Access Compliance Report

Public Rights-of-Way

Intersection ID: 9597	Main Street: DOUBLE_OAKS_RD	Cross Street: PEACEFUL_WAY_DR	Location: W
ADA ID: 74C35078CCE6	Ramp Type: PerpDiag	Initial Pass/Fail: Fail	Overall Compliance: No
			Severity Score: 33.75

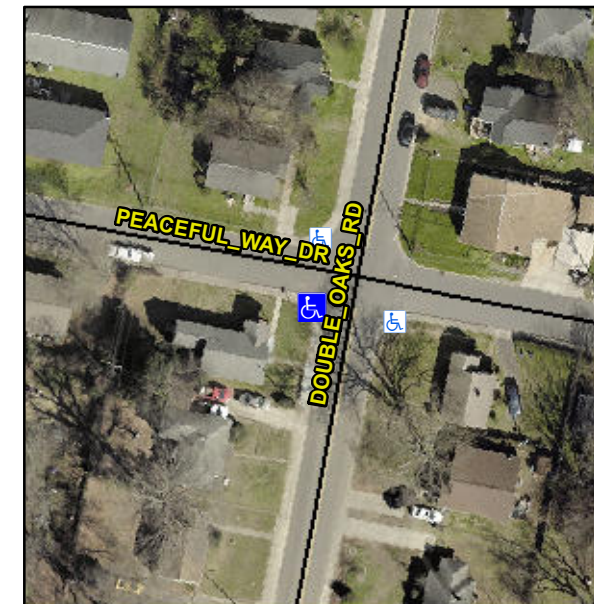
R304.5.1, R304.2.2, R304.5.3

Compliance	Description	Data	Compliance	Description	Data
N/A	Ramp Length (in)	66.5	No	Ramp Slope (%)	10.5
No	Ramp Width (in)	42.5	No	Ramp XSlope (%)	5.7
N/A	Flare Type LT	N/A	N/A	Flare Type RT	N/A
N/A	Flare Slope LT (%)	N/A	N/A	Flare Slope RT (%)	N/A
N/A	Flare Traversable LT?	N/A	N/A	Flare Traversable RT?	N/A
N/A	Landing Length (in)	N/A	N/A	DWS Provided?	N/A
N/A	Landing Width (in)	N/A	N/A	DWS Contrast?	N/A
N/A	Landing Slope (%)	N/A	N/A	DWS Length (in)	N/A
N/A	Landing X Slope (%)	N/A	N/A	DWS Full Width?	N/A
N/A	Landing Curb? (Y/N)	N/A	N/A	DWS Offset (in)	N/A
N/A	Shared Landing?	N/A			
N/A	Gutter Ponding?	N/A	N/A	Gutter Slope (%)	N/A
N/A	Gutter Lip Ht (in)	N/A	N/A	Gutter X Slope (%)	N/A
N/A	Painted X Walk1?	No	N/A	Painted X Walk2?	No
	X Walk 1 Direction	To SE		X Walk 2 Direction	To NE
N/A	X Walk 1 Width (in)	N/A	N/A	X Walk 2 Width (in)	N/A
	X Walk 1 Slope (%)	4.3		X Walk 2 Slope (%)	3.8
	X Walk 1 X Slope (%)	0.8		X Walk 2 X Slope (%)	8.1

Remove & Replace Curb Ramp With Two New Directional Ramps or Equivalent.
